## 2 RESPONSE TO COMMENTS ON THE DRAFT EIR

### 2.1 COMMENTS ON THE DRAFT EIR

RE: NOP- Draft EIR: Dublin Blvd –North Canyon Parkway Extension. SCH # 2017052047

**Subject:** San Francisco Bay Regional Water Quality Control Board Comments on the *Draft Environmental Impact Report for the Dublin Boulevard – North Canyons Parkway Extension Project, City of Dublin, Alameda County, California*  
**SCH No. 2017052047**

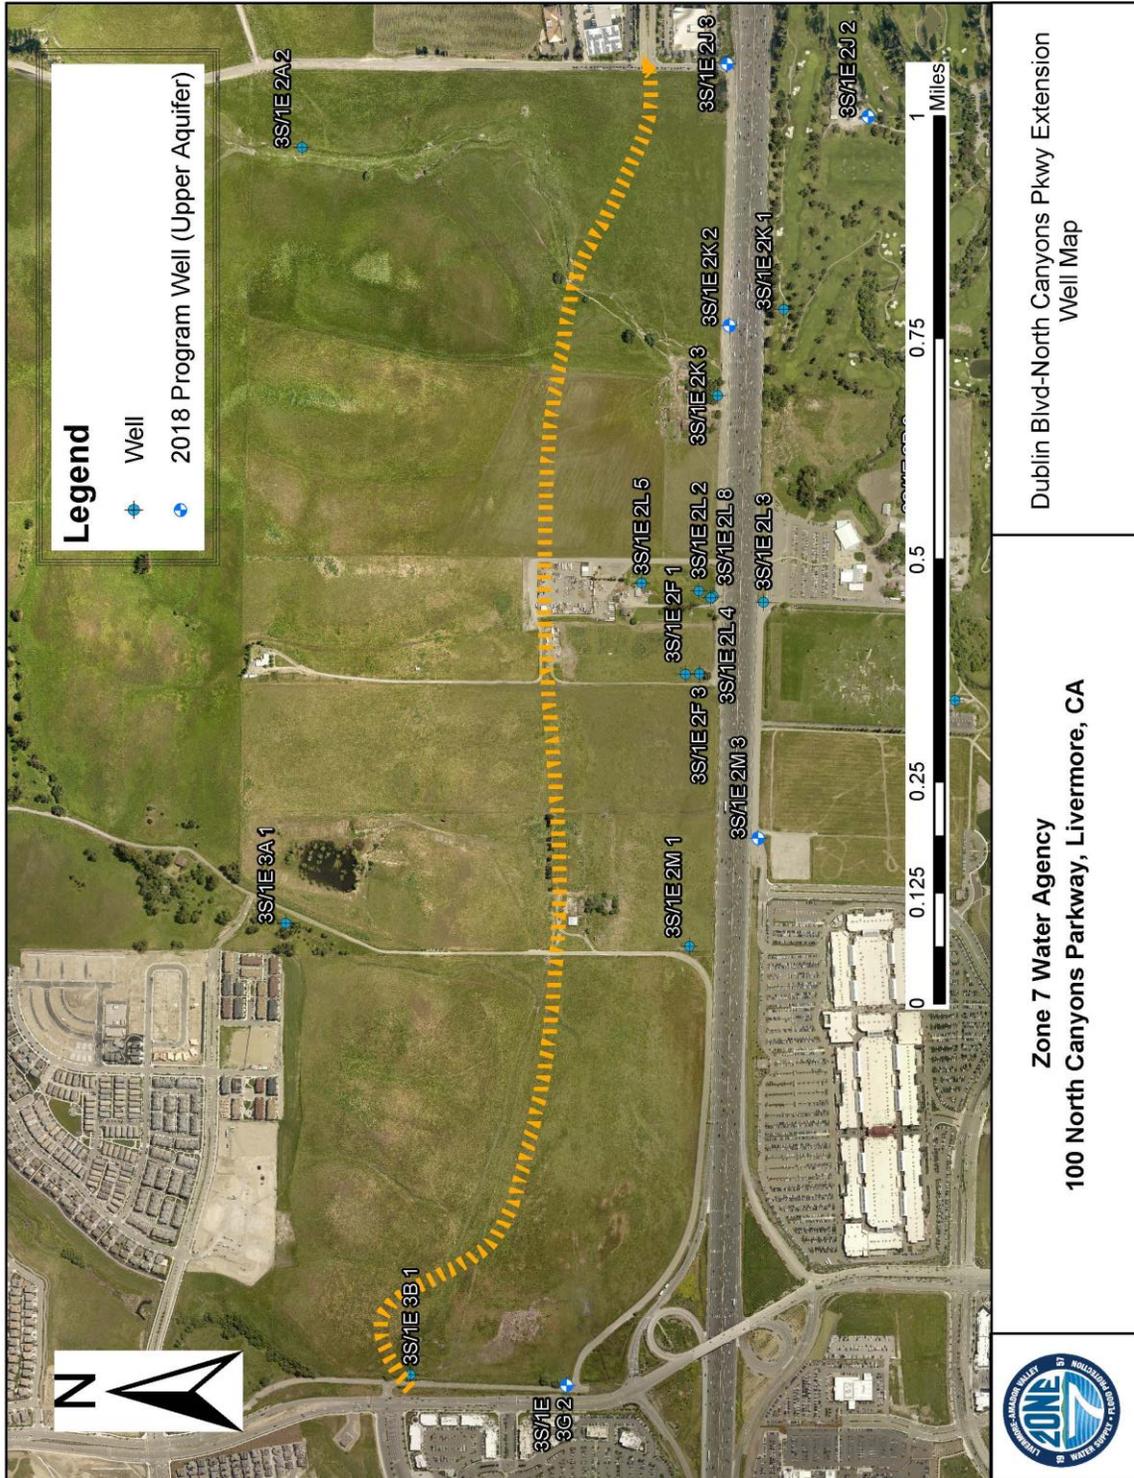
- 4-1 | 1. Well Records: Our records indicate there is one water well in the project area that will need to be protected or decommissioned (3S/1E03B01). The approximate location is shown on the attached Well Location map. Please immediately notify Zone 7 if any other wells exist in the project area. All well locations should be field verified and noted on the plans. If any of the wells are to be decommissioned, a well destruction permit must be obtained from Zone 7 before starting work. A Zone 7 drilling permit is also needed for any other water well or soil boring work that may be planned for this project. Well permit applications and the permit fee schedule can be downloaded from our website: [www.zone7water.com](http://www.zone7water.com), or requested by email sent to [wellpermits@zone7water.com](mailto:wellpermits@zone7water.com).

**Response to Comment 4-1:** Thank you for your comment. All required permits will be obtained, and permit conditions will be met prior to and during Project construction, as applicable.
